THE COACH HOUSE
4 PUTNEY PARK AVENUE
LONDON SW15 5QN

PROPOSED
BASEMENT FLOOR PLAN

10/944/200F

BASEMENT FLOOR PLAN

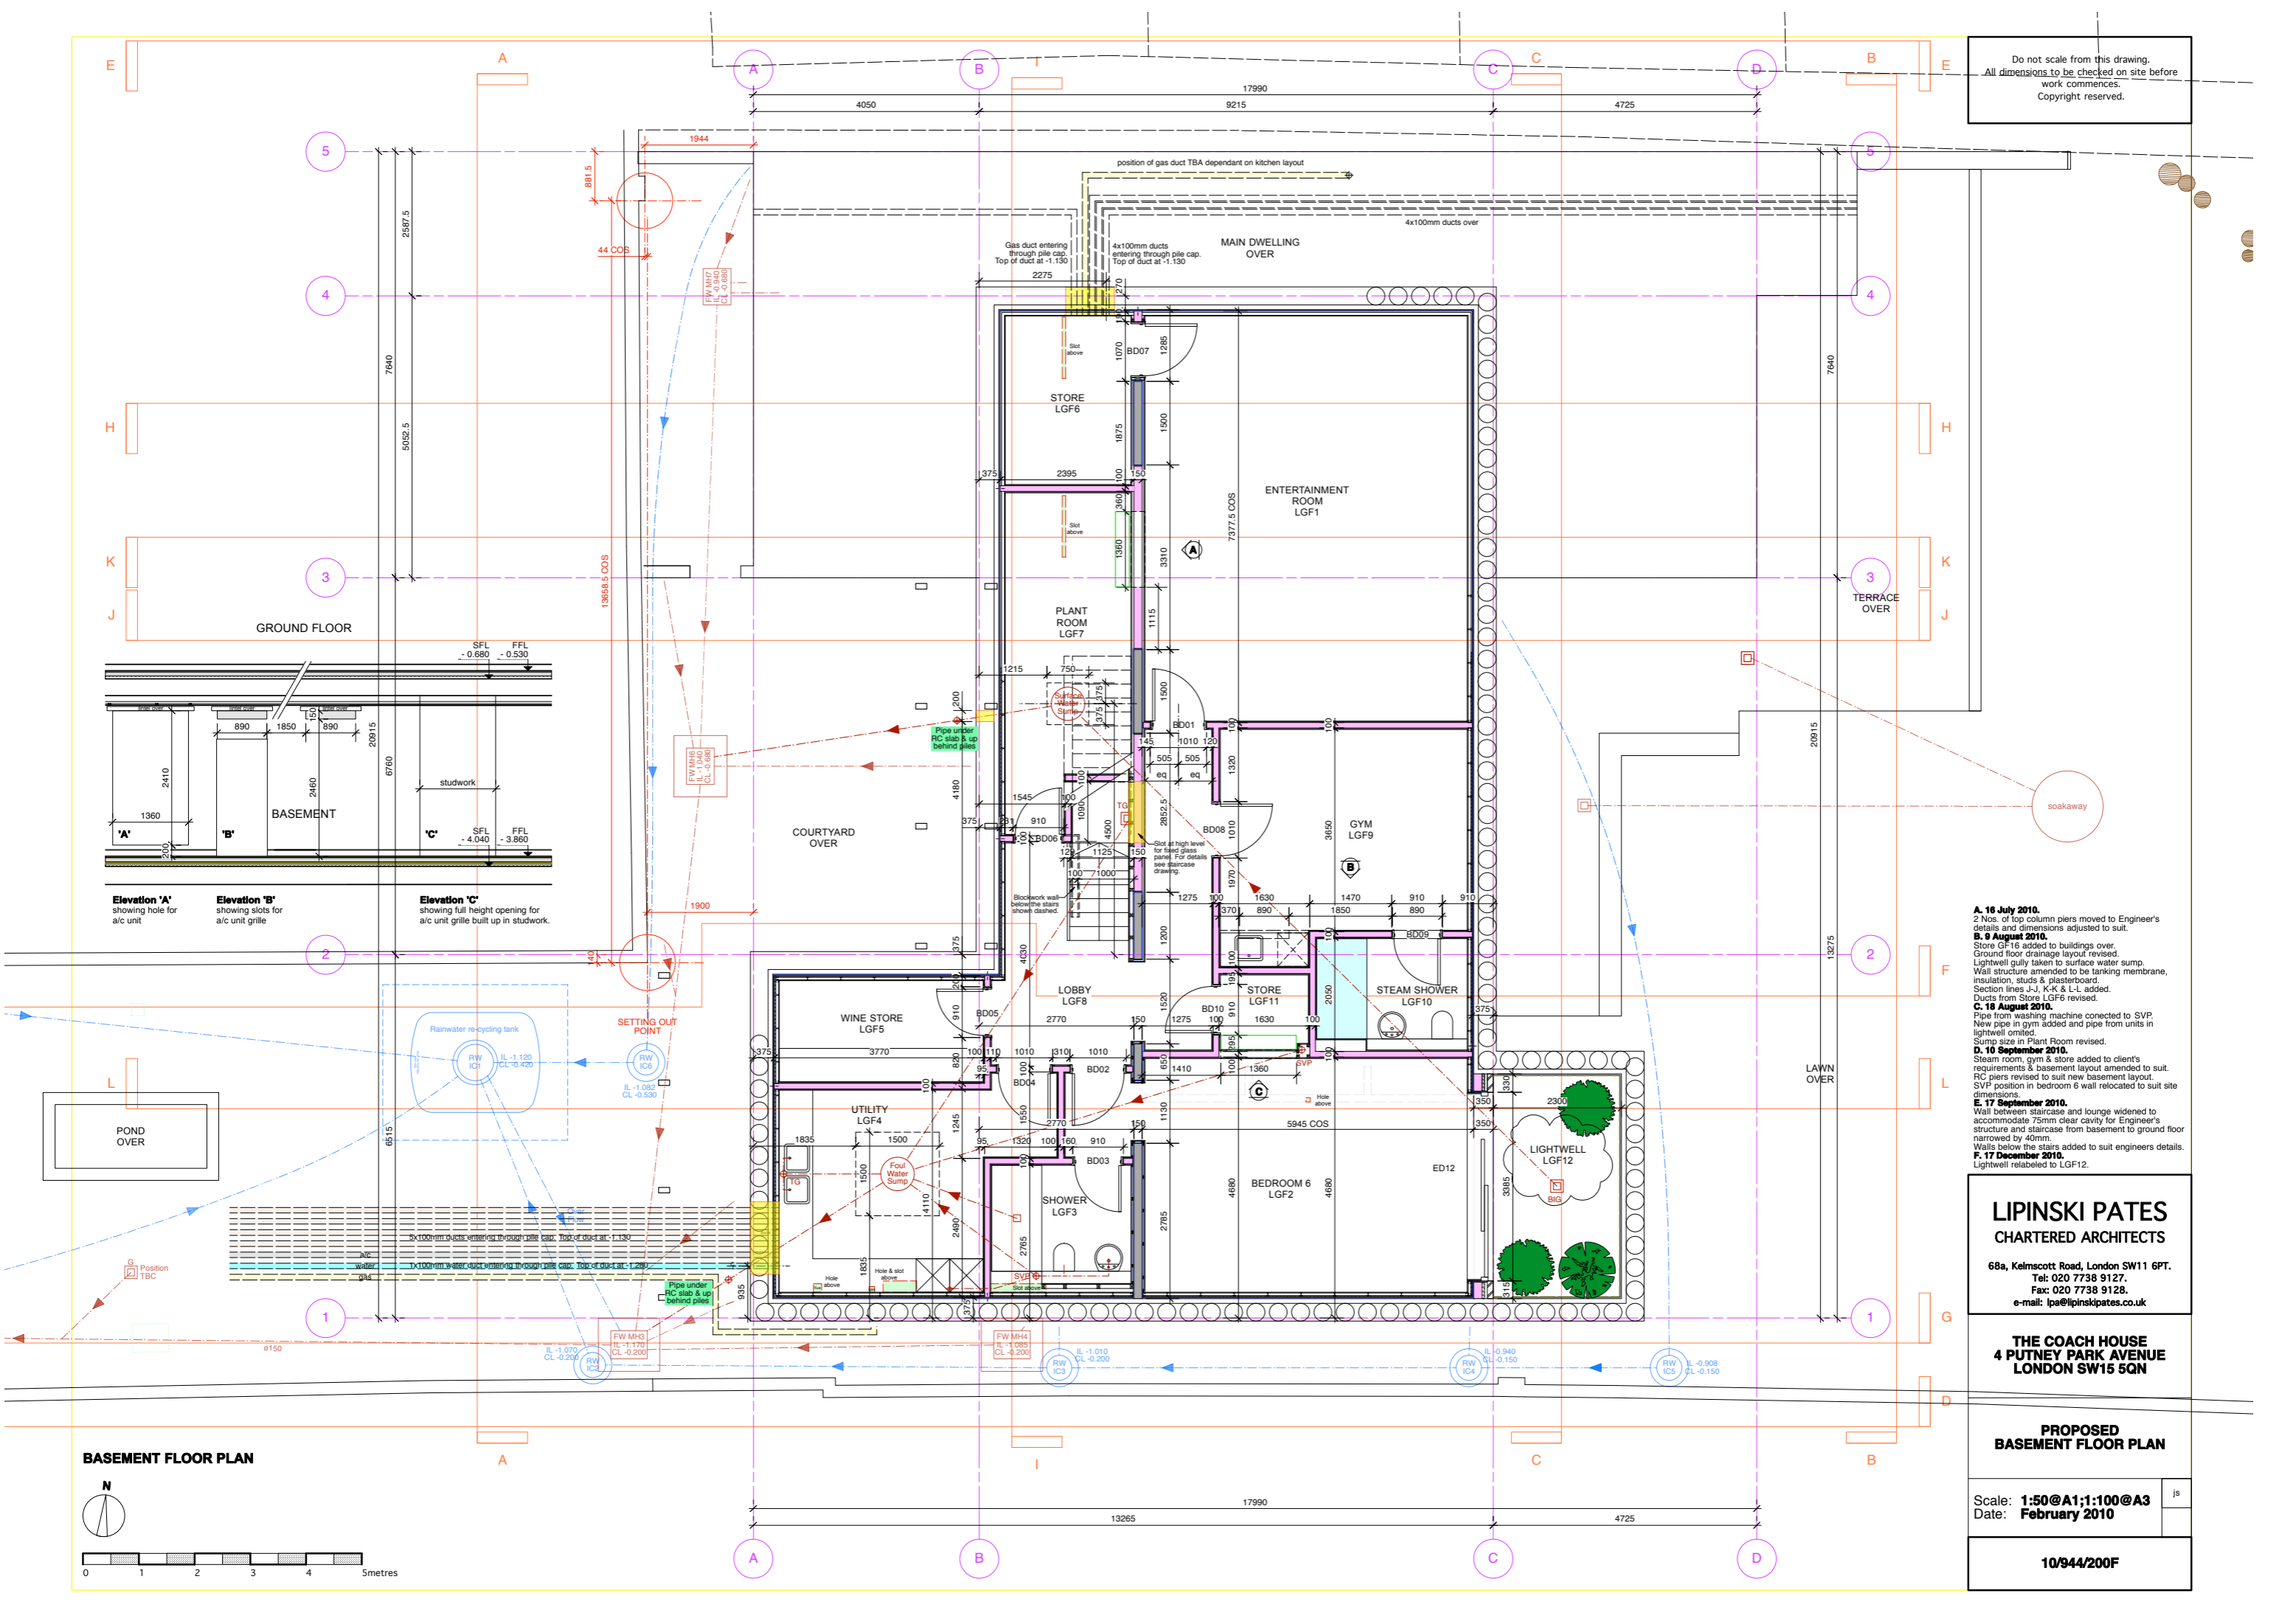
- A. 16 July 2010.**
2 Nos. of top column piers moved to Engineer's details and dimensions adjusted to suit.
- B. 9 August 2010.**
Store GF-16 added to buildings over. Ground floor drainage layout revised. Lightwell gully taken to surface water sump. Wall structure amended to be tanking membrane, insulation, studs & plasterboard. Section lines J-J, K-K & L-L added. Ducts from Store LGF6 revised.

- C. 18 August 2010.**
Pipe from washing machine connected to SVP. New pipe in gym added and pipe from units in lightwell omitted. Sump size in Plant Room revised.

- D. 10 September 2010.**
Steam room, gym & store added to client's requirements & basement layout amended to suit. RC piers revised to suit new basement layout. SVP position in bedroom 6 wall relocated to suit site dimensions.

- E. 17 September 2010.**
Wall between staircase and lounge widened to accommodate 75mm clear cavity for Engineer's structure and staircase from basement to ground floor narrowed by 40mm. Walls below the stairs added to suit engineers details.

- F. 17 December 2010.**
Lightwell relabelled to LGF12.
